MFN 12-076

Subject: NRC Requests for Additional Information (RAI) Related to the Audit of the Economic Simplified Boiling Water Reactor (ESBWR) Steam Dryer Design Methodology Supporting Chapter 3 of the ESBWR Design Control Document – Draft Response for RAI 3.9-285

Draft Response for RAI 3.9-285

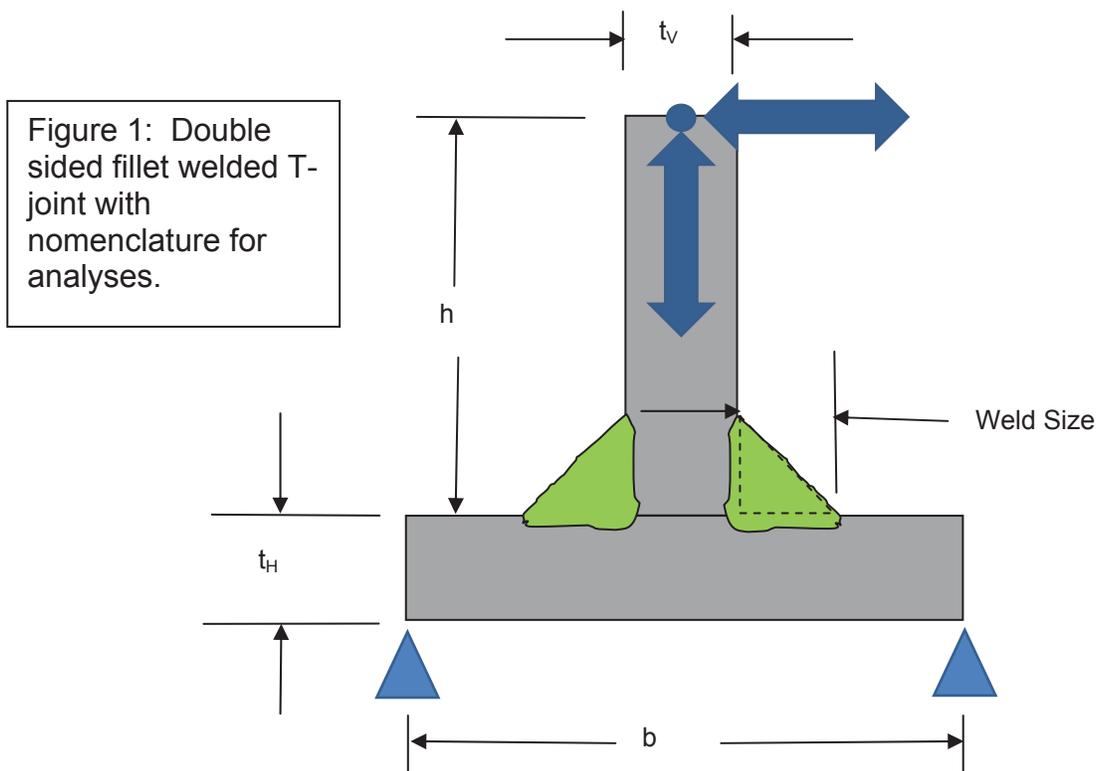
To provide information to conclude that method (2) provides a more conservative result than method (1) the NRC Staff requested GEH to perform additional analyses. The NRC Staff requested that GEH use a T-joint for the analyses and to reduce the configuration to a 2-D approach. A typical double sided fillet welded T-joint used for ESBWR steam dryer design is shown in figure 1, an ASME BPV Code Section III NB-3352 Type V weld joint.
